Assessment of Dam Safety Coal Combustion Surface Impoundments (Task 3) Draft Report

Duke Energy Corporation

Miami Fort
Generating Station

December 4, 2009

PROJECT NO. 20085.1050
DATE: 11/2009
FIGURE 5C

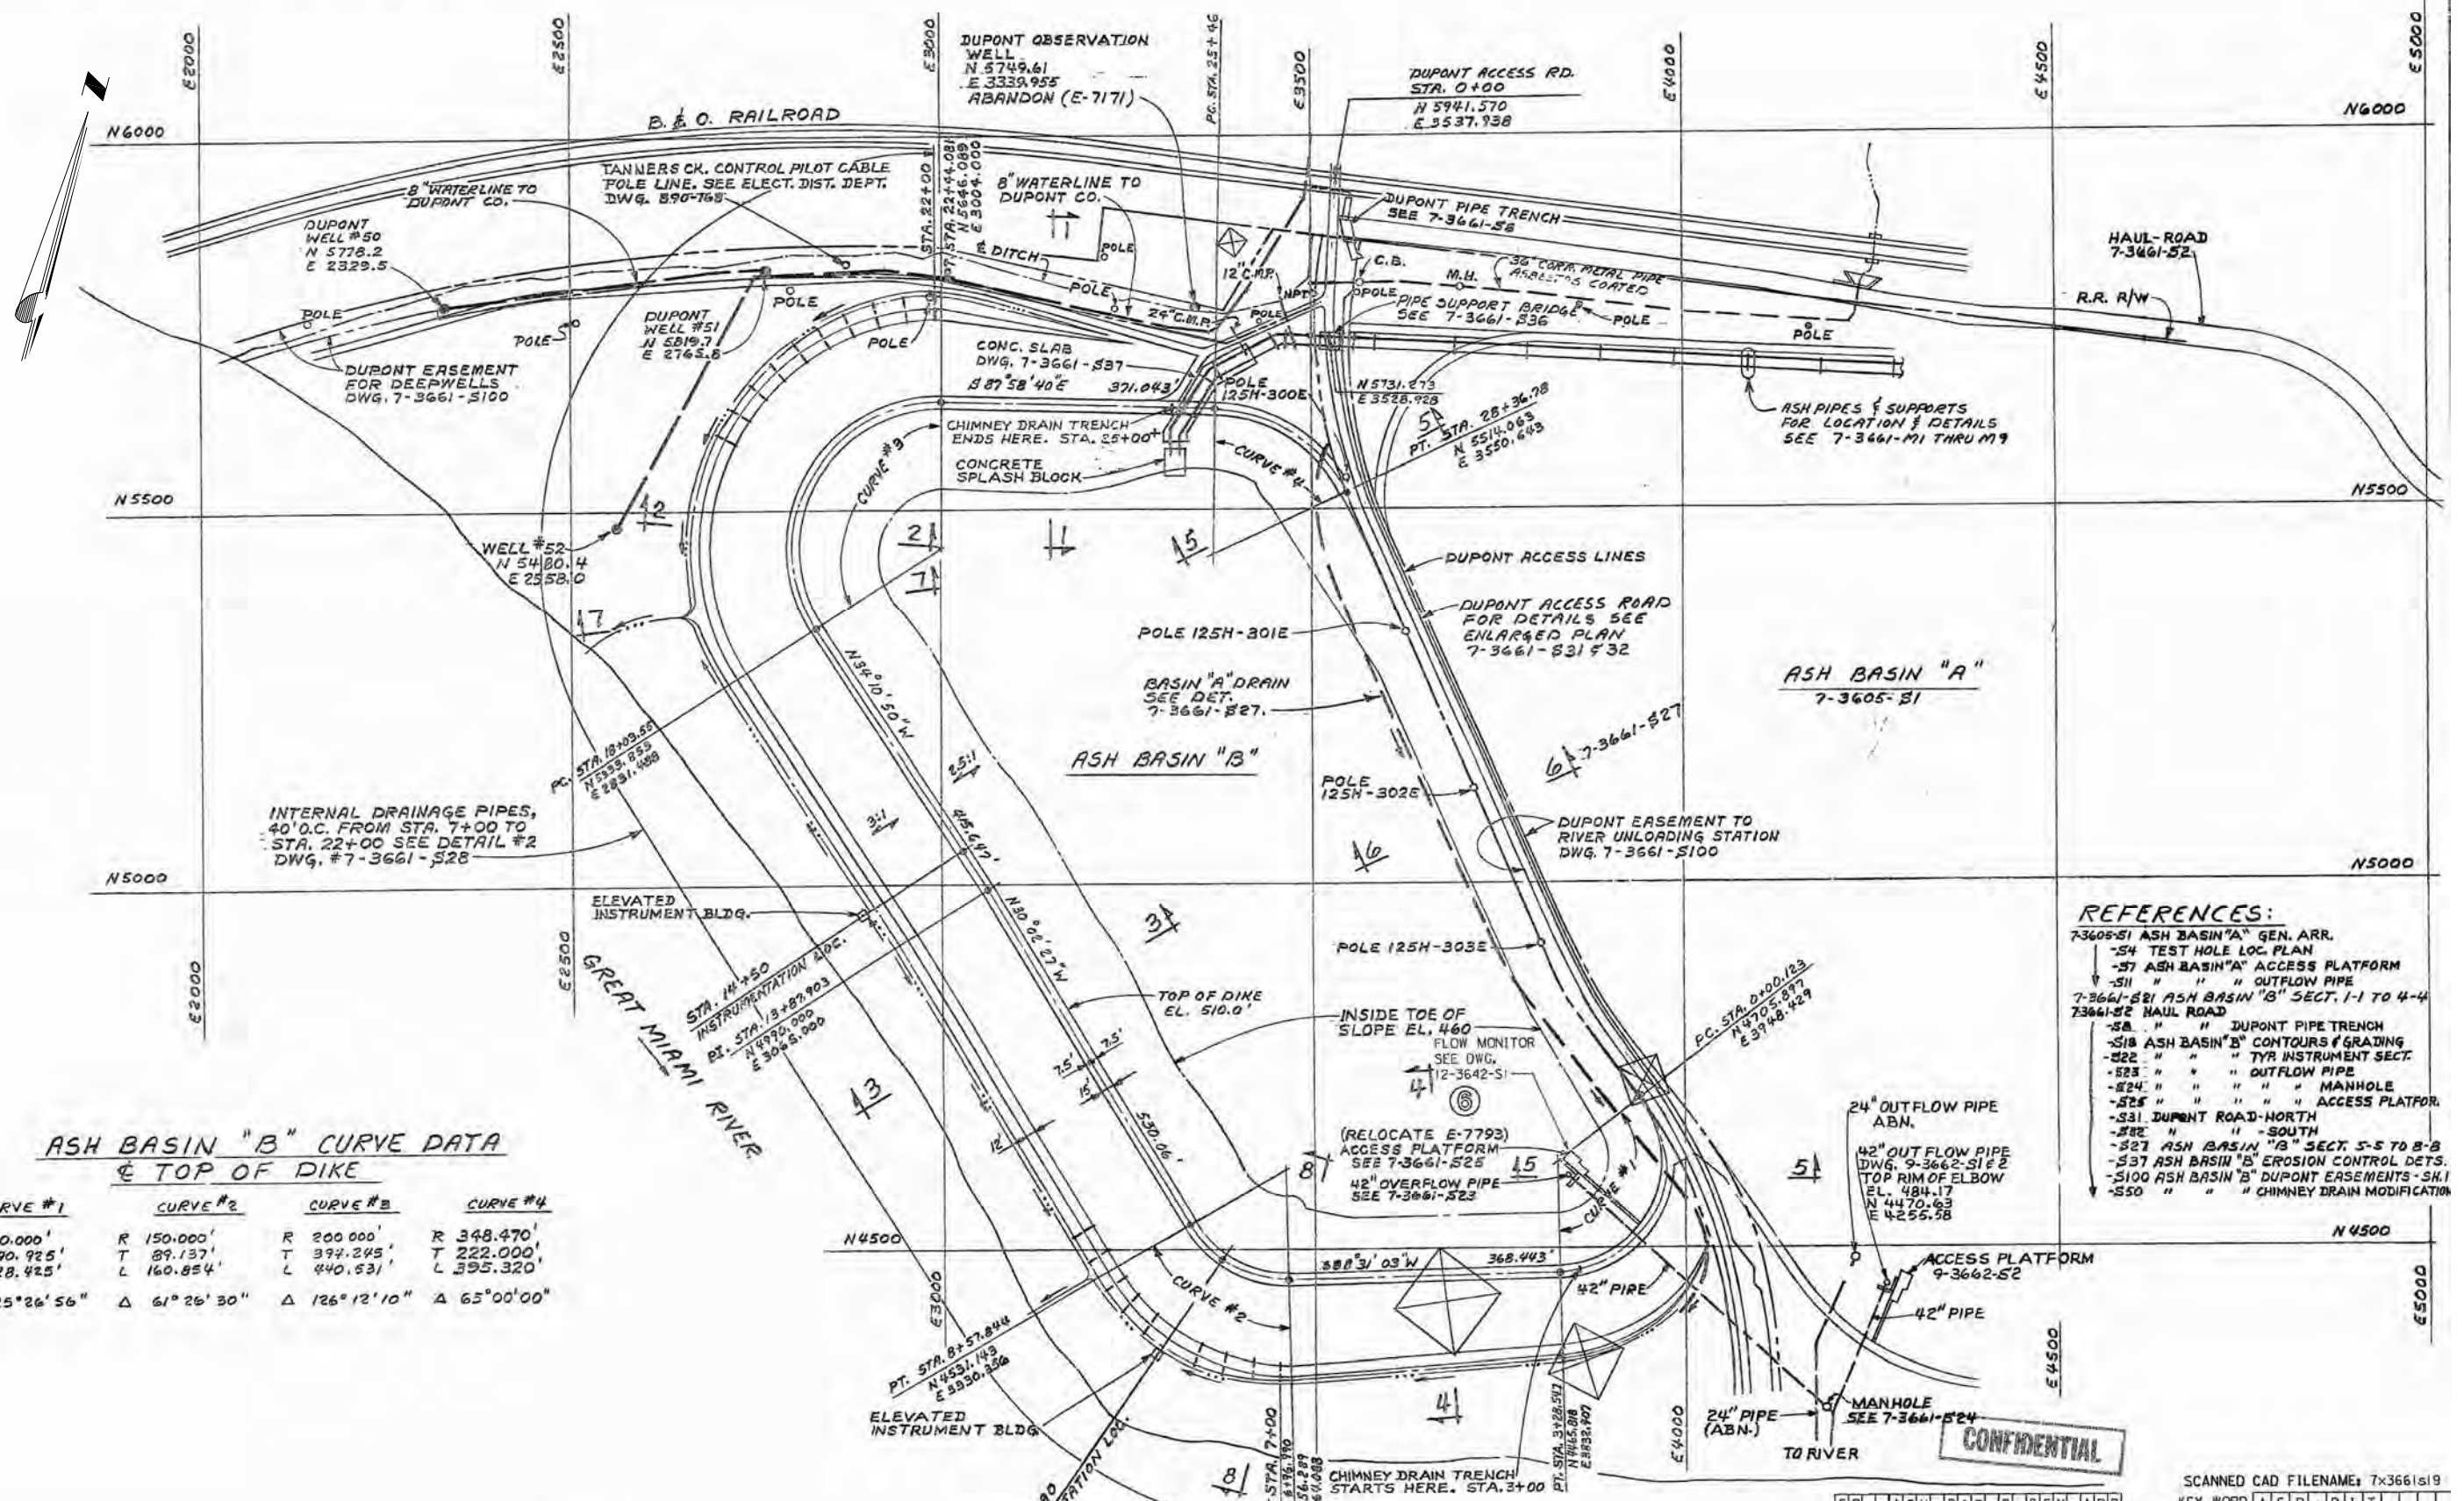
- The pond surface elevation was not provided within the report;
- The analysis assumed the use of cement stabilized fly ash at the toe of the embankment and as a surface seal. Construction documents as shown on Figure 5C indicate that the toe and shell cover has been replaced with a clay soil material. No additional analysis was completed for this substitution.
- No piezometers are in place to measure the phreatic surface in the embankment; and
- No flow monitoring is conducted of the chimney drain outlet pipes as shown in Figure 5C and Photos No. 46 and No. 47.
